Community Consultation & 1976 Flood

Save Our Hills (Upper Hutt) Inc.

UHCC - PC42 Hearing

44 Whitemans Road

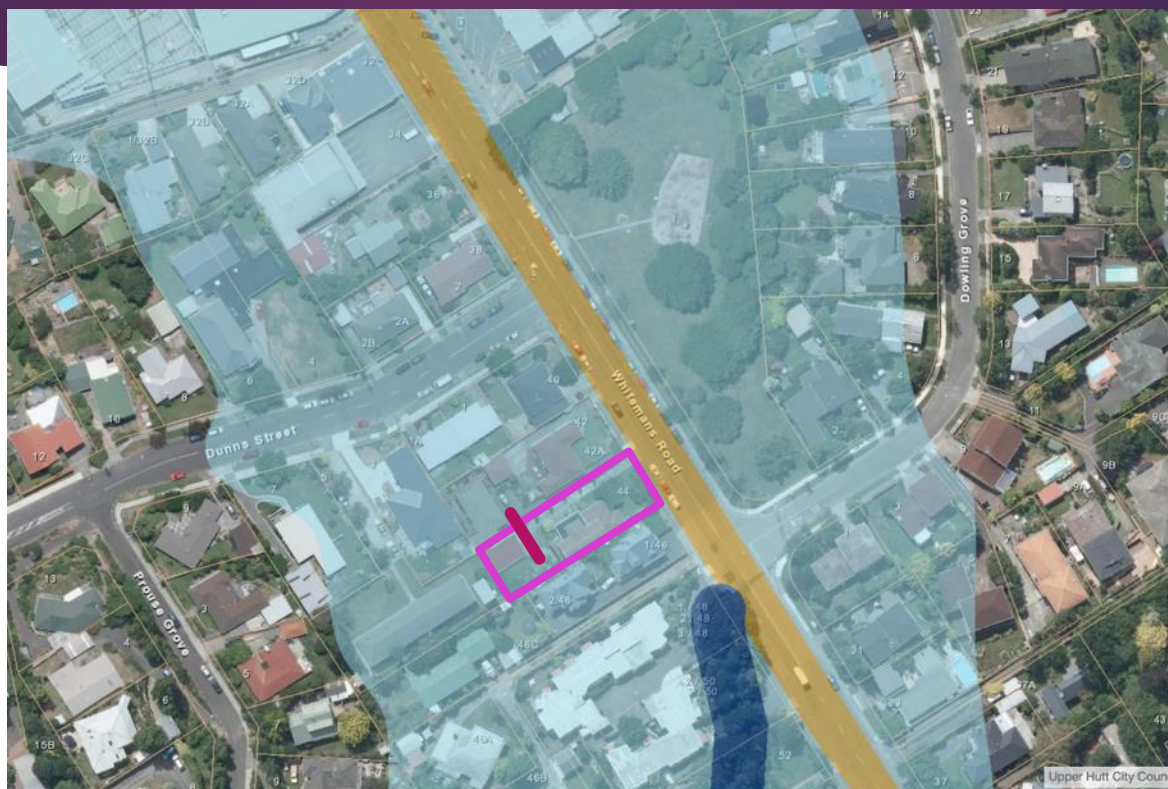
“We were concerned whether the water would come inside..... Over the length of the house the land rises by 280 mm so an estimate can be made that the water was 420mm at the gate.... The flood plan blue shaded area runs to the rear of the section behind our house. If this is water level then the water height at the gate would have had to have been 1120mm (1.12m).”

Pinehaven Road
June 2010 Map (GWRC)

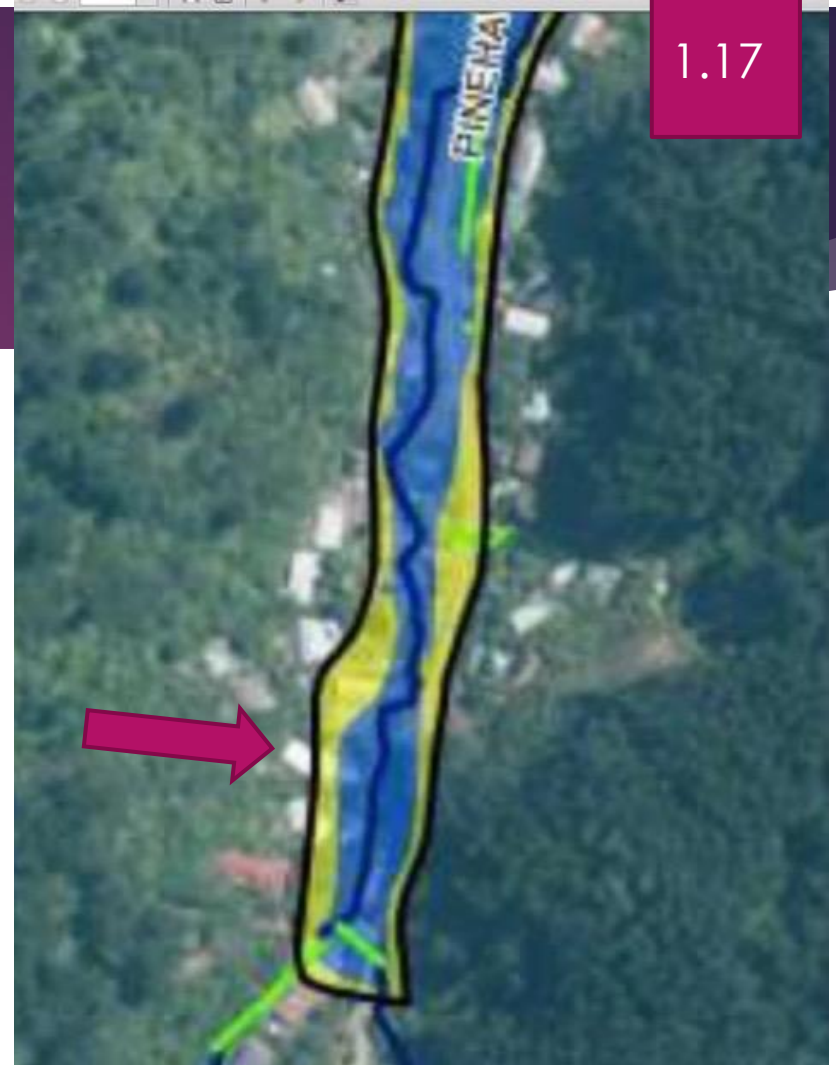
- The map legends say yellow is “flood sensitive area”. What does that mean?
- Alistair Allan (GWRC) said it is freeboard.

- **Why is freeboard 1,500mm (1.5m)?**

- **We asked the GWRC Hearing Panel for a further independent review, because GWRC's revised 2015 flood maps do not make the flood situation any clearer than their 2010 flood maps. Instead we got sham Focus Group meetings and seven more useless flood maps!**
